JUNEAU STAKE
CENTER

Subject: Juneau LDS Chapel – Highway Access Permit Application

From: Daniel Park [DPark@mcgalaska.com]
Sent: Wednesday, January 25, 2012 7:03 PM
To: Nicole Jones
Cc: Hobbs, Naomi
Subject: Juneau LDS Stake Center - Response to Comments received thus far
Follow Up Flag: Follow up
Flag Status: Red
Attachments: geoblock5150_Design_and_Construction_Overview[1].pdf; cp fire lane 061307.JPG

PROPOSAL: A Modification to an existing Conditional Use permit for 17,101 square foot church in a D-1 residential zone. The modification is to the access off of Glacier Highway and the location of the structure.

Sheet Title:
OVERALL
SITE PLAN

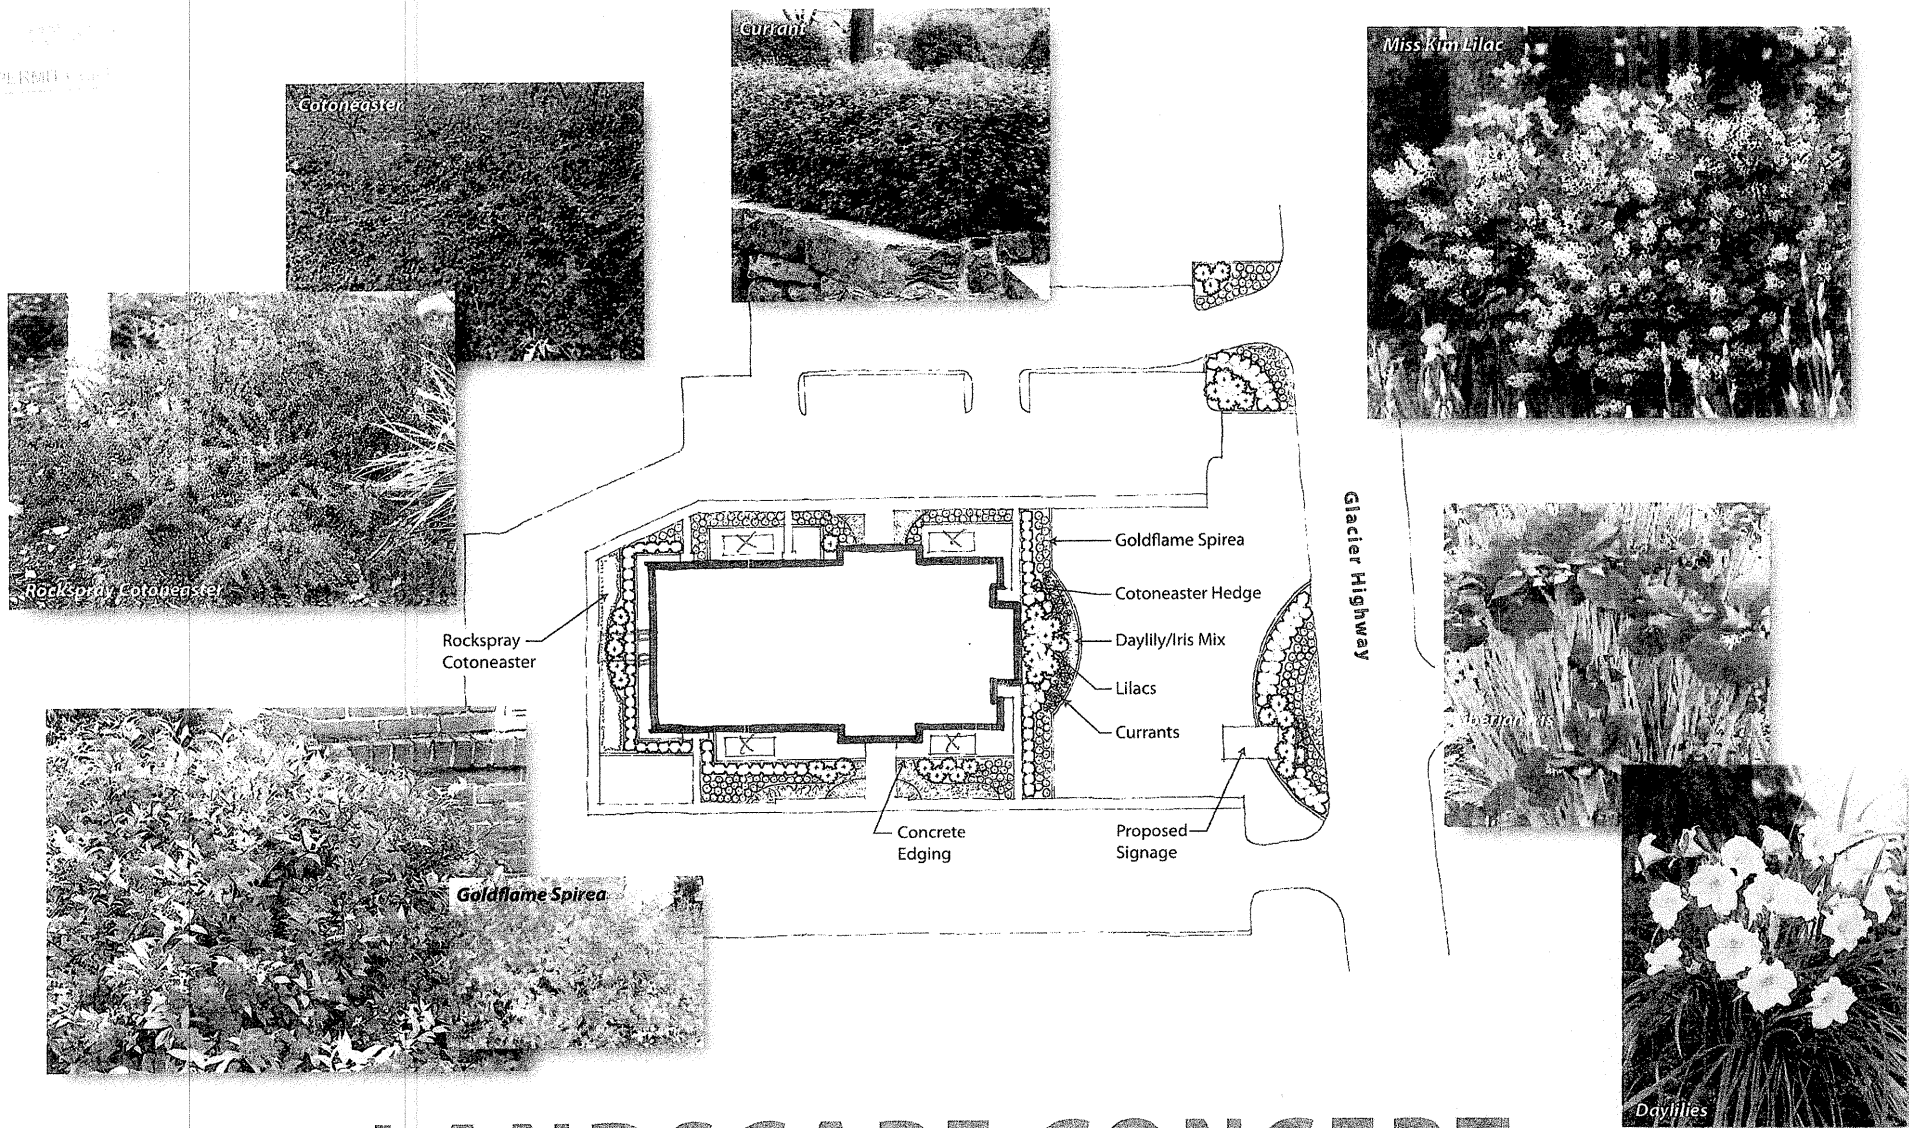
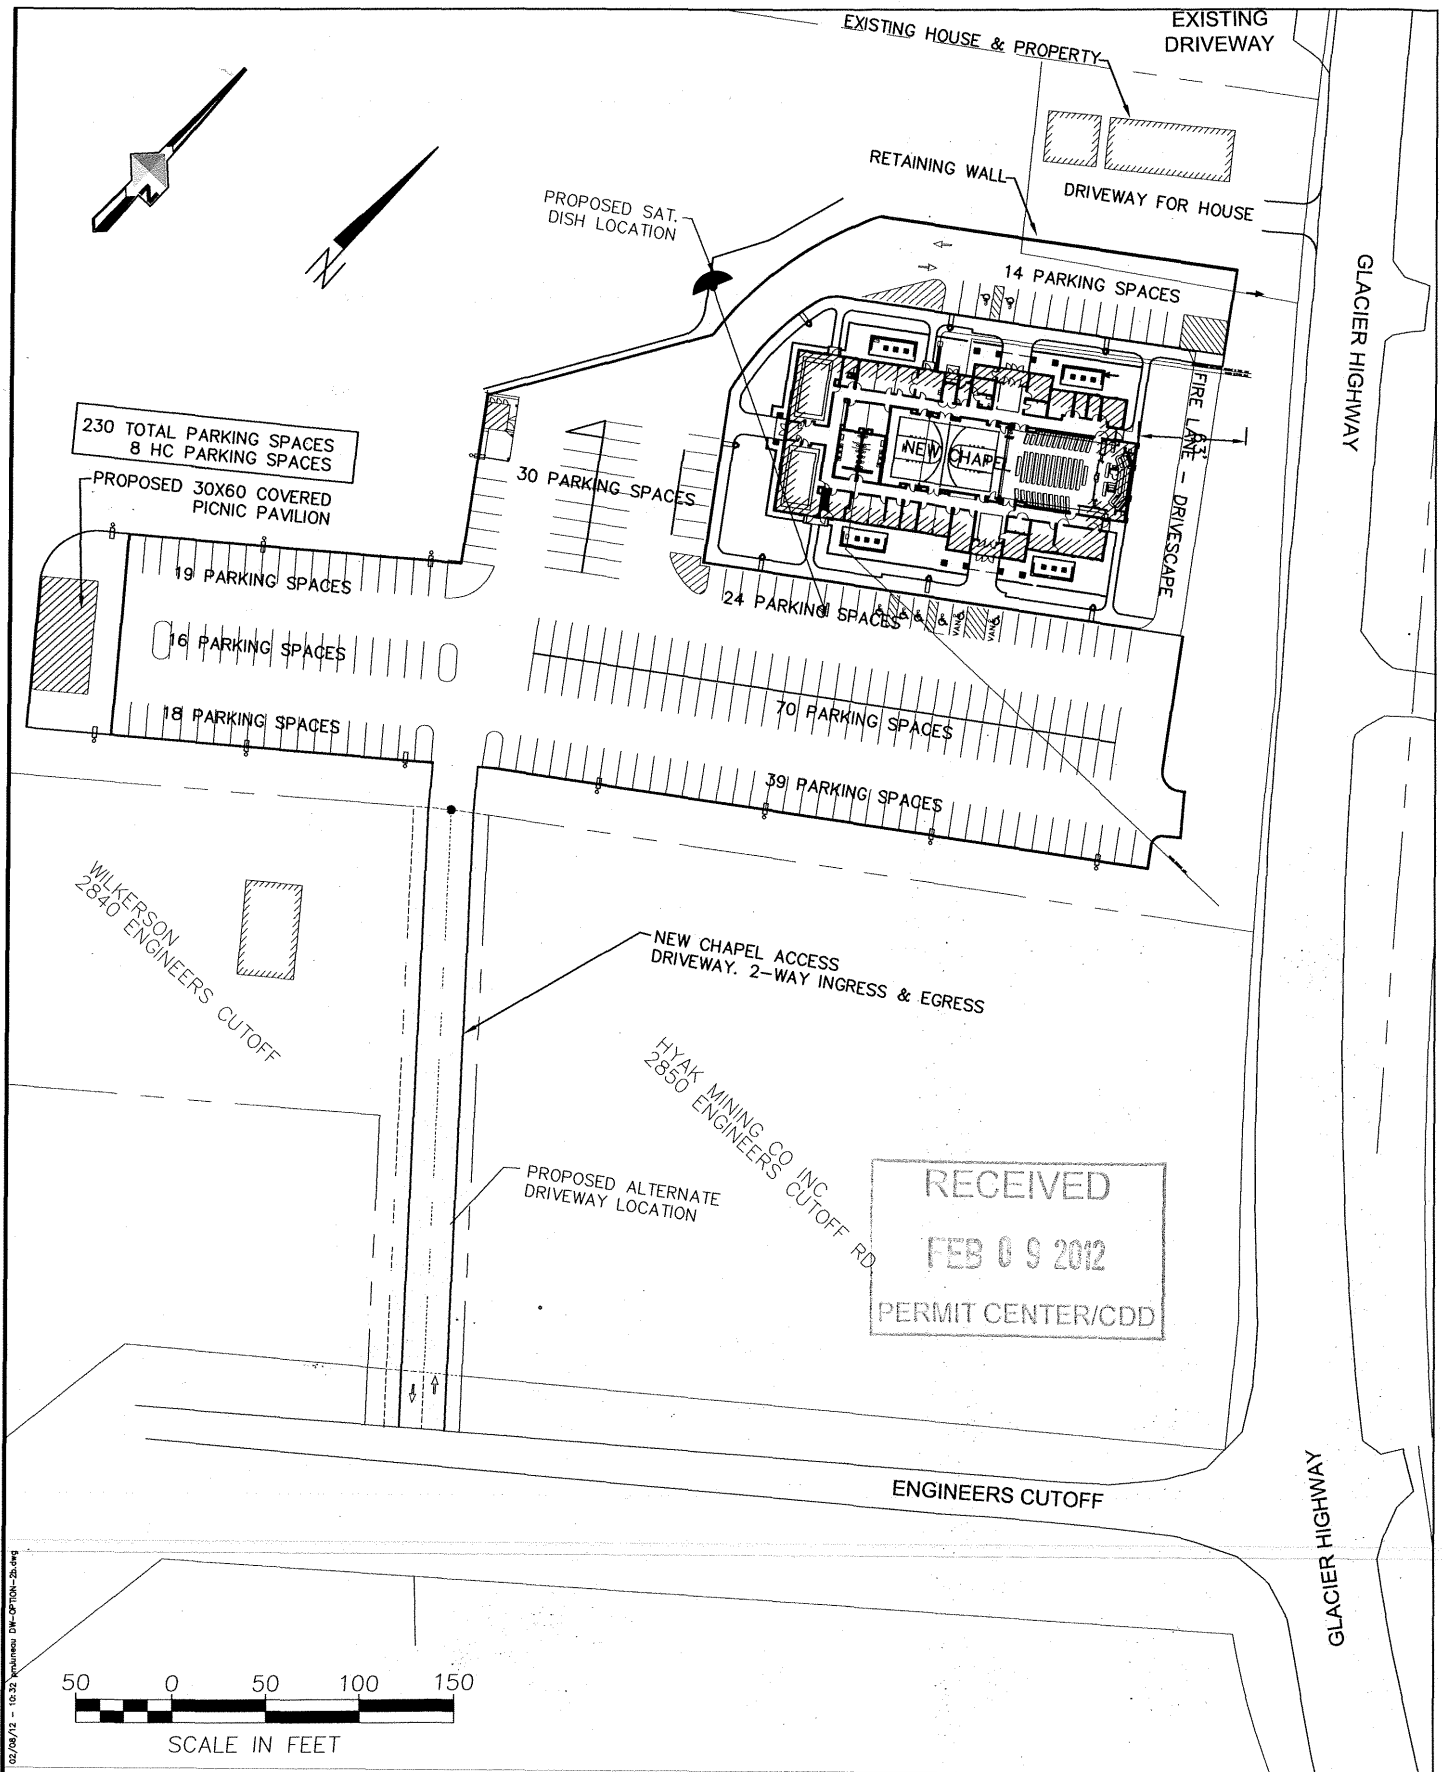
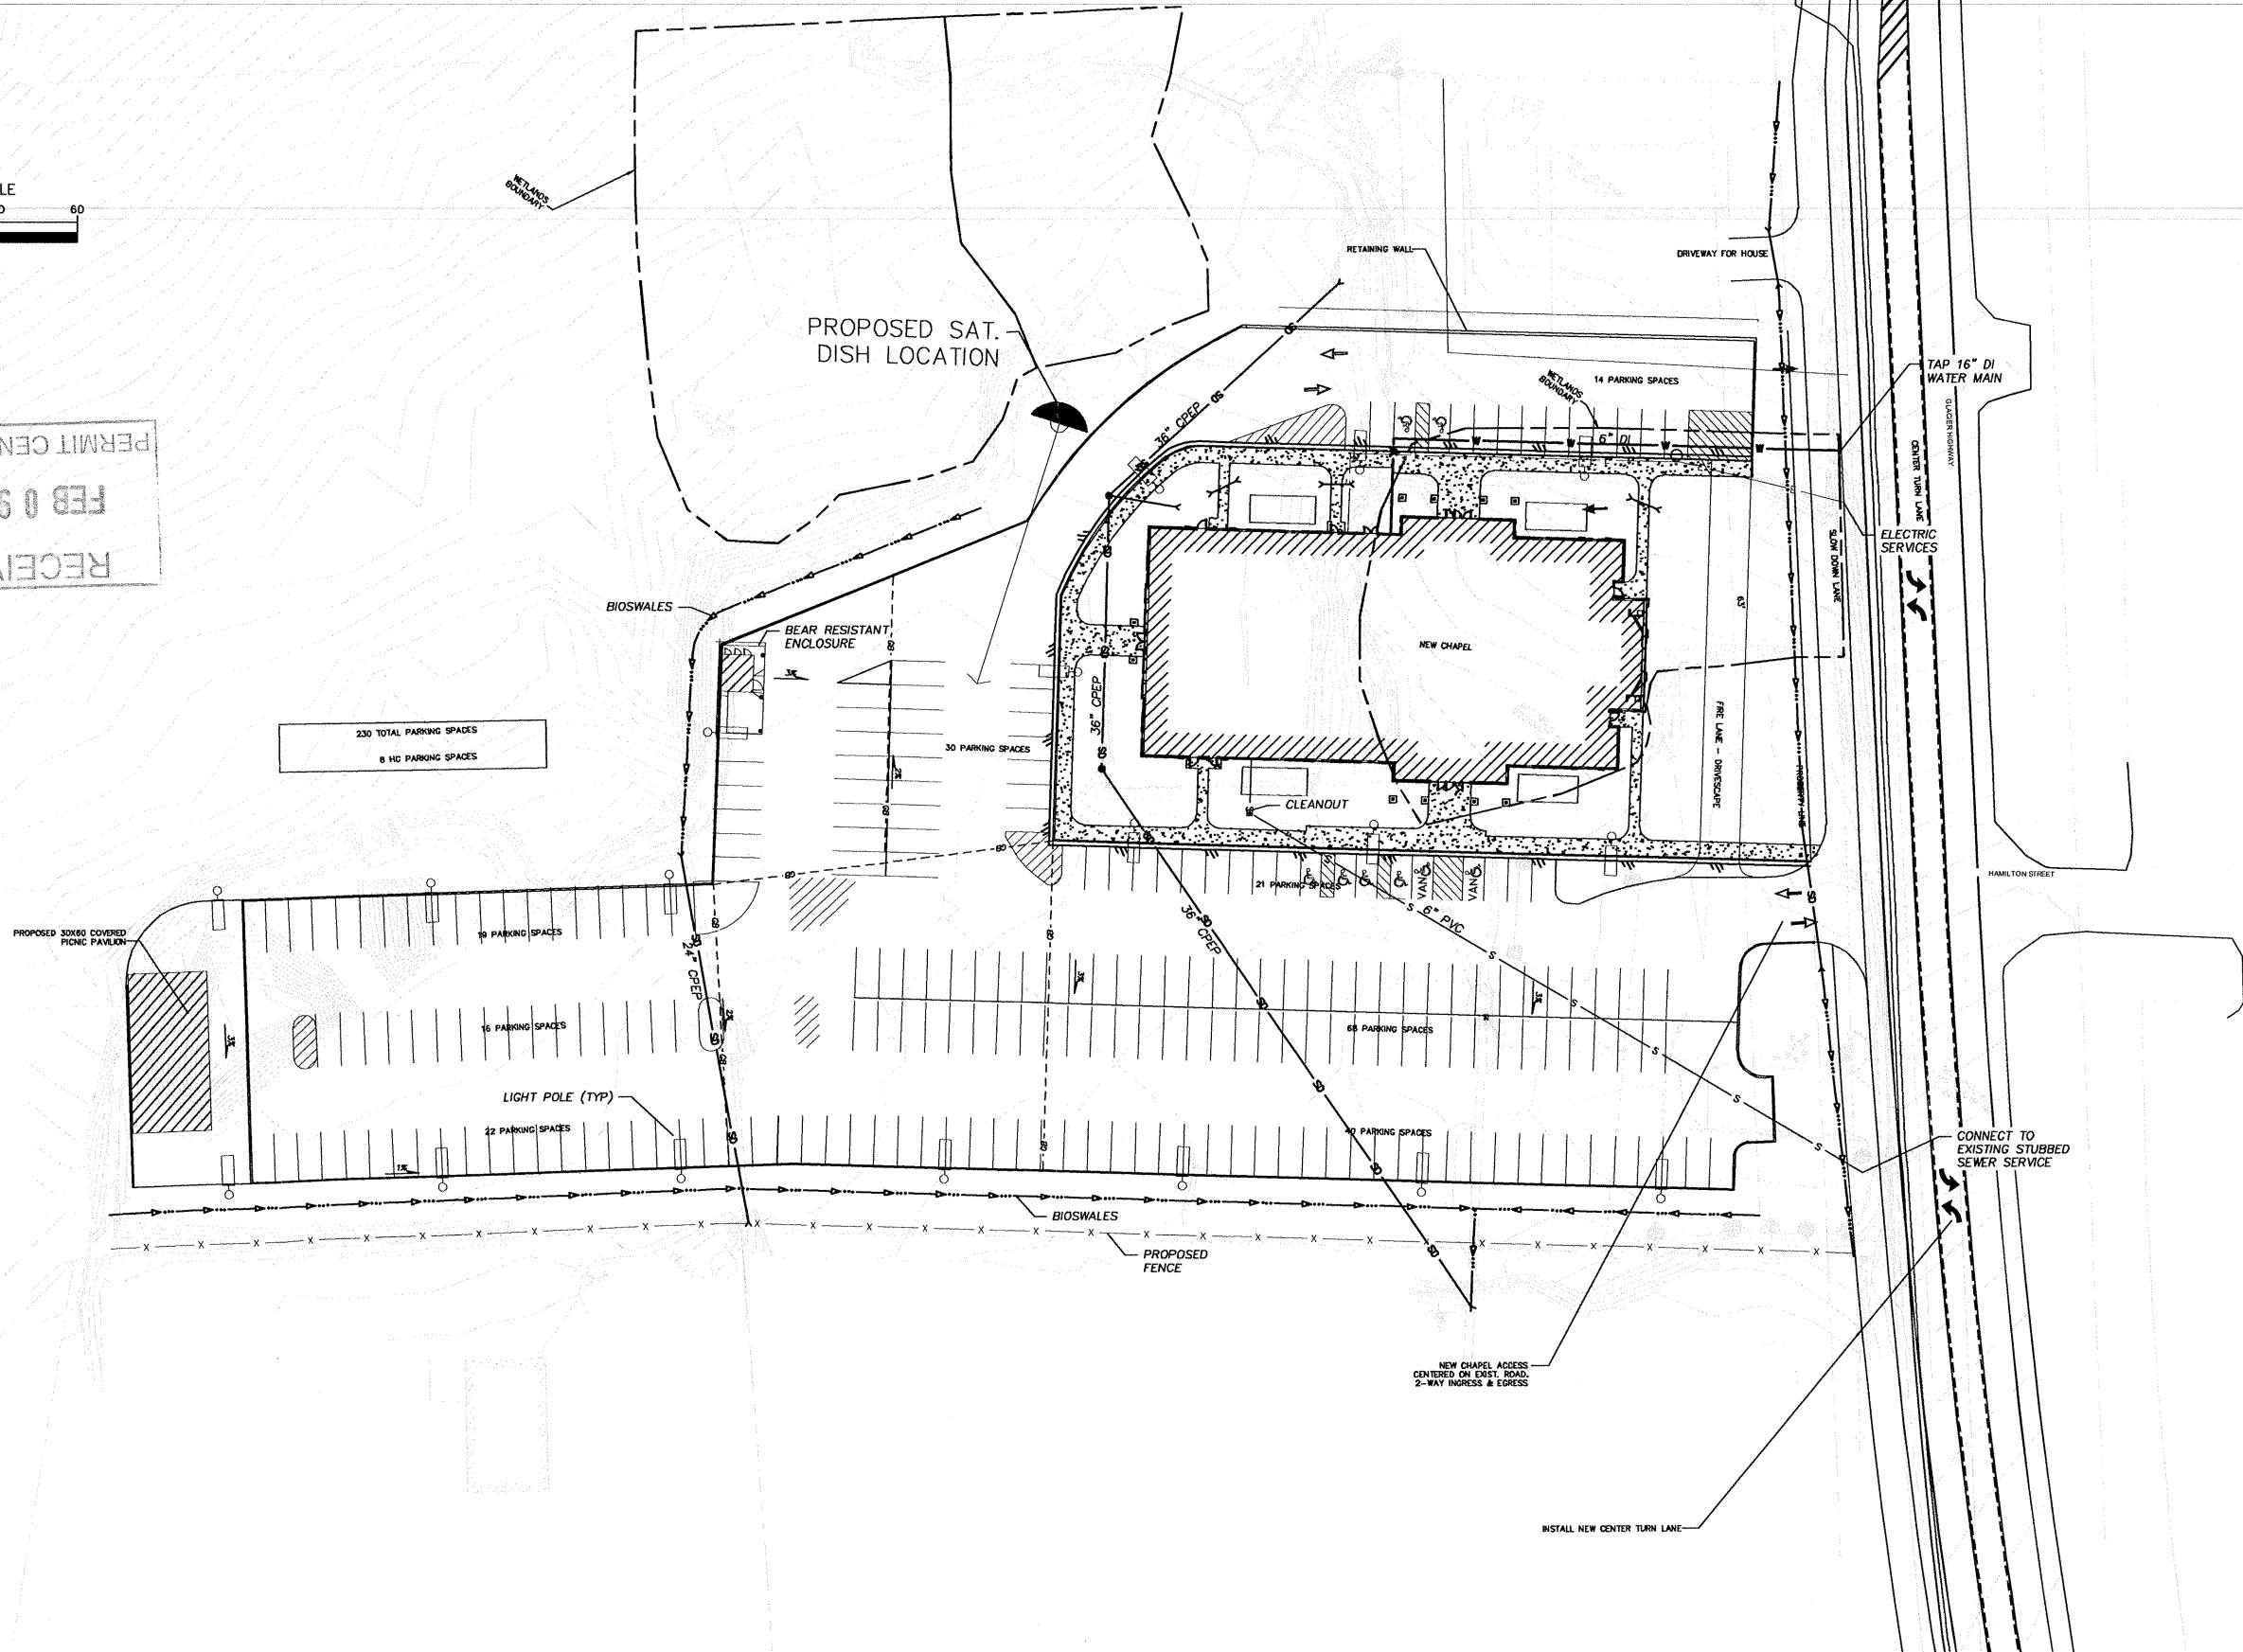
Final design may require stormwater runoff calculations and tweaking of the site plan. In addition, they will need to specify maintenance w/schedule of the BMPs. This will be clarified during building permit review but we should give a heads-up to the designer.

The only concern on fire code and requirements is the driving surface or "drivescape" being able to withstand the weight of at least a 75,000 pound fire truck. If that can be guaranteed and that the surface will hold a rig that size without it sinking into the ground, then this is ok as far as fire review goes.

Our Fire Marshall reviewed the information that you sent regarding the fire lane and has a remaining question. Could you provide additional information regarding how that space will be maintained in the winter time? Specifically, will it be plowed free of snow?

If that is the Fire Marshall's request, which certainly makes sense, that will be the plan. I noticed the turf drive at the Temple in Anchorage was plowed. So it just needs to be part of the maintenance plan and plowing agreement managed by the Facilities Management folks with the Church. We will plan on installing plow markers on both ends of the turf-drive so they will know where to plow.
